City of Portland, Maine – Building or Use Permit Application 389 Congress Street, 04101, Tel: (207) 874-8703, FAX: 874-8716

DATE: 12 June 97 ADDRESS: 19 Kent St.
REASON FOR PERMIT: To Construct patio room
BUILDING OWNER: Alicia Greenwald
CONTRACTOR: MAINE WINDOW & SIDING CO.
PERMIT APPLICANT: William APPROVAL: 1/2, 8, 9, 10, 27 ~~DENIED~~

10 X 12
PATIO Room

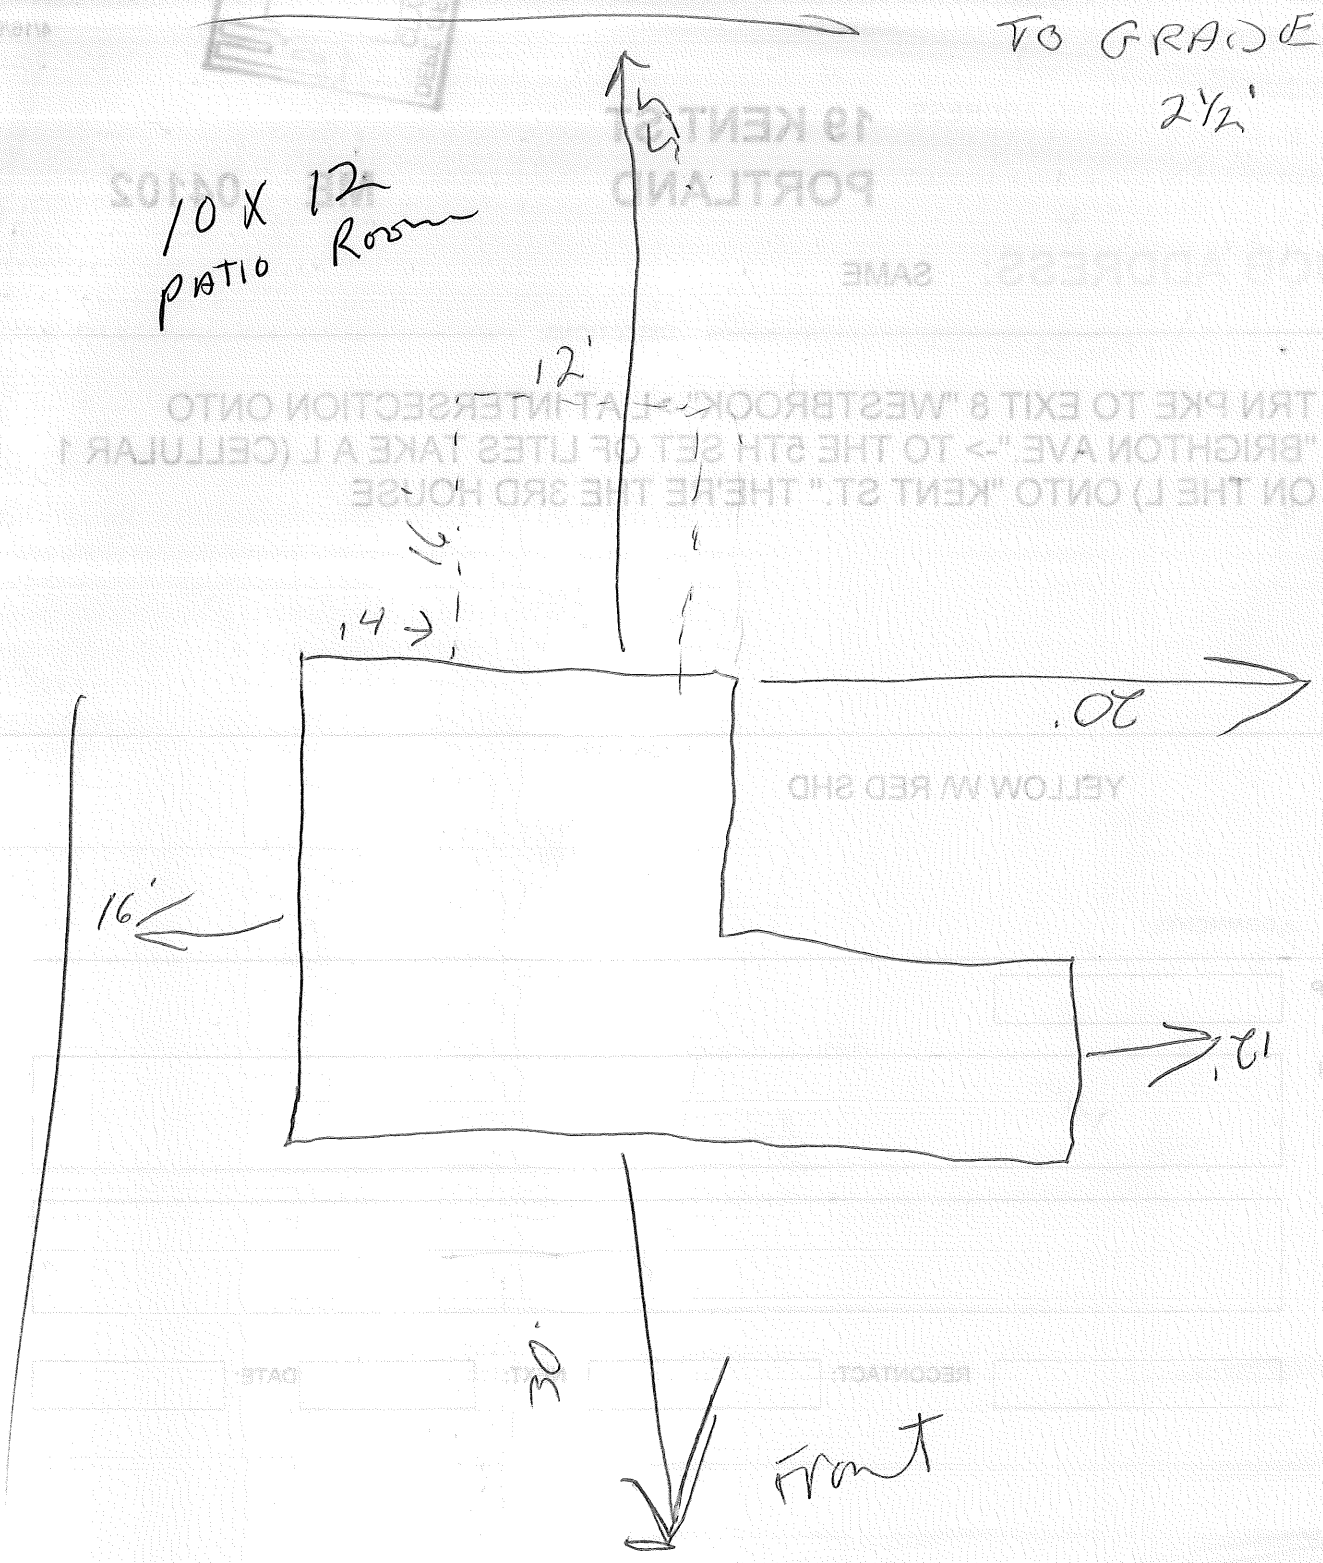
ENTER. TRIM TO MATCH BRASSING TRIM
AS NEAR AS POSSIBLE,

MAKE DECK LEVEL WITH INSIDE FLOOR.
MUST CALL ABOUT OIL PIPES

TO GRADE
2 1/2'
